IIH Task Force Conference Call January 23, 2015

Karin opened the meeting with discussion and information about the oil filter spacer plate IMTS fabricated and Karin forwarded to Afton for use on their next test. Comments from Ed Altman and Karin disclosed modifications required for clearance and that the plate was needing an additional surface fly cut for the O-ring sealing and spacing requirements to position the plate.

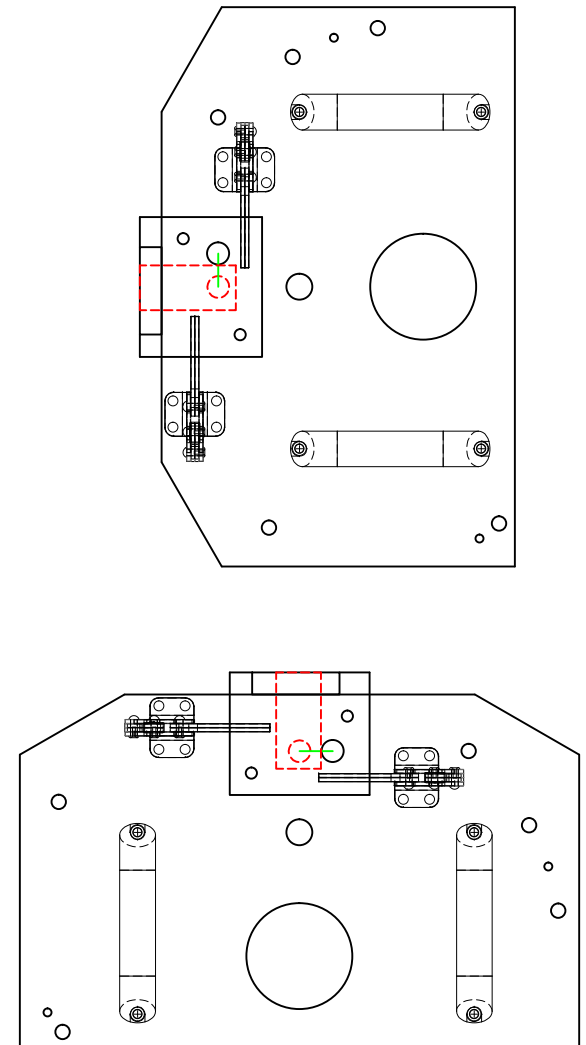
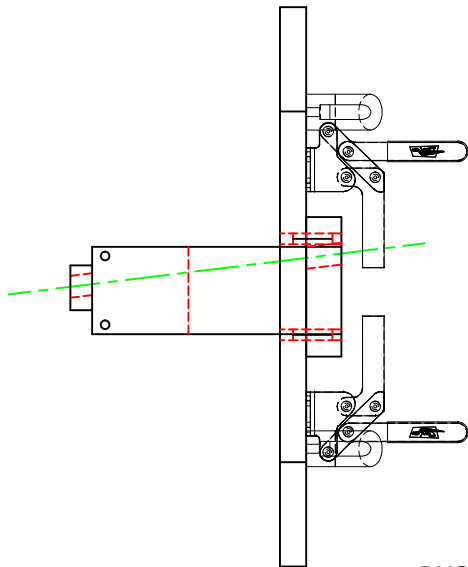
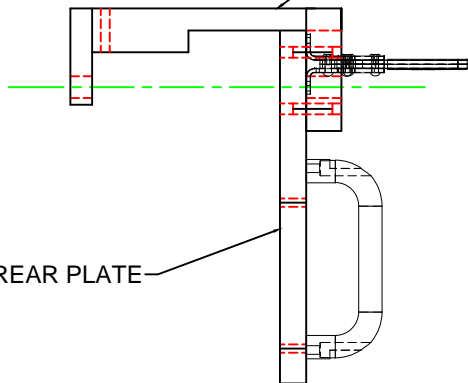
Karin asked to focus on discussion about the block modification and Dave Passmore explained the proposed design on the tooling to install the thermocouple using tooling from the rear of the engine. See Attachment 1

The plan would be to have tooling to make the pilot hole through the rear of the block and adaptor fixtures to attach to the master plate for drilling and tapping the 1/16th pipe female thread for the thermocouple.

The group discussed earlier thoughts about using an O-ring with a straight thread deciding too much material would be removed from the main oil gallery housing. The group continued discussion talking about the drilling and tapping process focused on how to incorporate a stop in the tapping process. George expressed concern about using a shoulder to stop the tap so the operators would not go excessively deep. The group reviewed the drawings provided for the discussion agreeing this would become part of the procedure.

George suggested having a ring groove to indicate the tap was at the proper depth vs a positive stop as additional torque on the tap would then possibly pull and weaken the threads. The group seemed to agree a ring with an identifying color would be the better process.
